Staff Findings of Fact and Exhibits

Project: JUNCTION ATHLETIC COMPLEX SP-2016-0607D
Ordinance Standard: 1992 Land Development Code, as amended by Ord. 941205-A
Variance Request: Fill exceeding four feet of depth, 13-7-16(a)

**RE: Junction Athletic Complex (SP-2016-0607D) –
Fill Exceeding Four Feet of Depth Variance Request – Ordinance 910221-E §13-7-16(a)**

CUT & FILL MAP
VARIANCE EXHIBIT

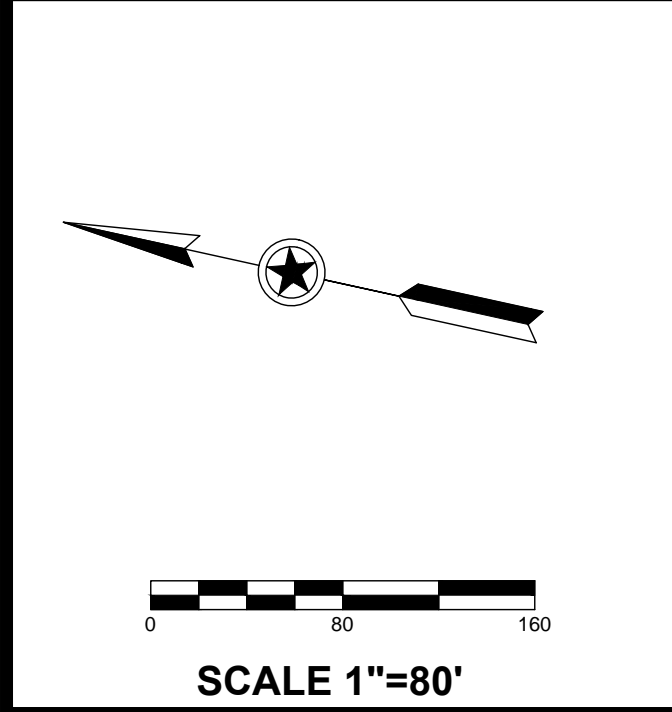
Yes. Fill depths exceeding four feet are necessary for the access drive so the owner of the property will not be prevented from enjoying the privilege of accessing their site from the right-of-way. Additionally, existing site topography and off-site flows entering the site requires the conveyance of off-site flows across the access drive, which necessitates a culvert and an increase in excess fill material.

No. Concurrently, due to the siting and size of the building, outdoor pool, and a future Phase 2 parking structure, excess fill material is required for the fire access drives around the structures to meet slope requirements set forth by the Travis County Fire Marshall. However, this is not a unique condition of the property because any other proposed development may be able to be situated on the property such as to avoid the need for excess fill material for fire access drives. Therefore, the excess fill material for fire access drives is a unique condition created as a result of the method of land development by the applicant.

No. Thirdly, a small area of excess fill material is needed for the water quality control facility berm. The applicant states the orientation of the uplands area on the property and the requirement to dedicate 40% of the uplands as a contiguous undisturbed area requires the developed areas to be narrow in width and deep into the property in order to facilitate a reasonable use of the land. However, per Ordinance 941205-A, LDC 13-2-563(e) is amended to allow water quality controls in the Water Quality Transition Zone. Therefore, the applicant would be able to design the site to accommodate the required water quality volume without exceeding the allowable depth of fill by extending the width and breadth of the controls into the Water Quality Transition Zone.

Yes. The amount of fill exceeding four feet is limited to what is necessary to provide access to the site and to allow for the implementation of culverts to convey off-site drainage flows.

No. However, the amount of fill exceeding four feet to allow acceptable fire access drive slope requirements for the Travis County Fire Marshall and to allow the necessary fill needed for the height of the water quality control berm is beyond the minimum departure from the terms and conditions of the Land Development Code to facilitate a reasonable use.

Staff Recommendation: Staff recommends the variance to allow excess fill necessary to provide access to the site. Staff does not recommend the variance to allow excess fill necessary for the fire access driveways or the water quality control berm.
